Informal document GRSP-57-15
(57th GRSP, 18-22 May 2015,
agenda item 3(a))

Proposal for amendments to global technical regulation No. 9 (Pedestrian safety)

**Submitted by the expert from the European Commission as Chair of
the Task Force on Bumper Test Area within the Informal Working
Group on global technical regulation No. 9, Phase 2 – Proposal of
amendments to Proposal of amendments to
ECE/TRANS/WP.29/GRSP/2015/2.**

"Figure 5A

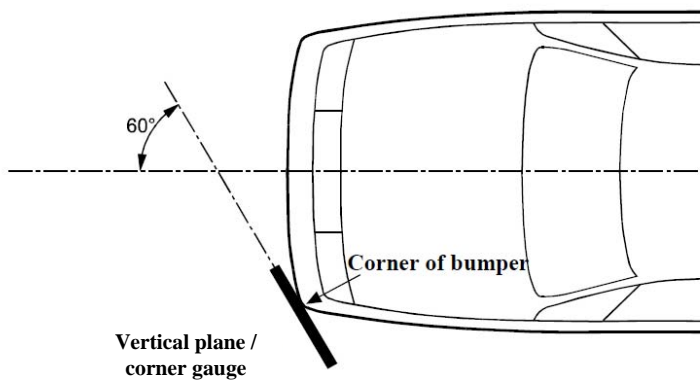
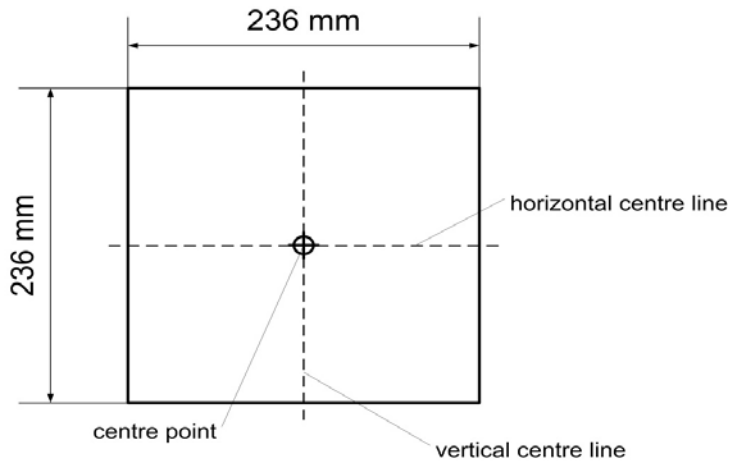
Figure 5, amend to read:

Corner of bumper example (see paragraph 3.14., note that the corner gauge is to be moved in vertical and horizontal directions to enable contact with the outer contour/ front fascia of the vehicle)

Figure 5C
Determination of the corner of bumper with the corner gauge (shown in random location)

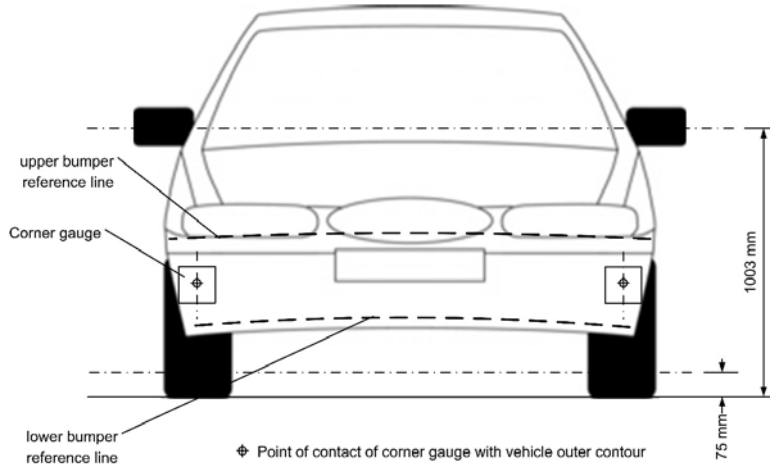
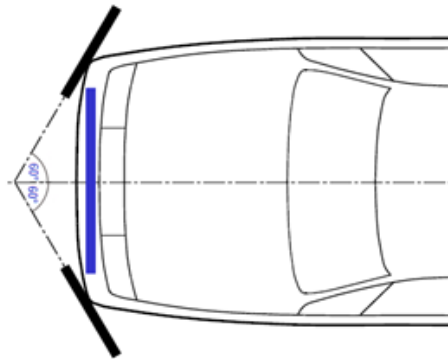
For determination of the corner of bumper, the front surface of the corner gauge is moved parallel to a vertical plane with an angle of 60° to the vertical longitudinal centre plane of the vehicle (see Figures 5A and 5C) at any height of the centre point of the corner gauge between:

For determination of the corner of bumper, the gauge is moved to contact the outer contour/front fascia of the vehicle touching at the vertical centre line of the gauge. The horizontal centre line of the gauge is kept parallel to the ground plane.
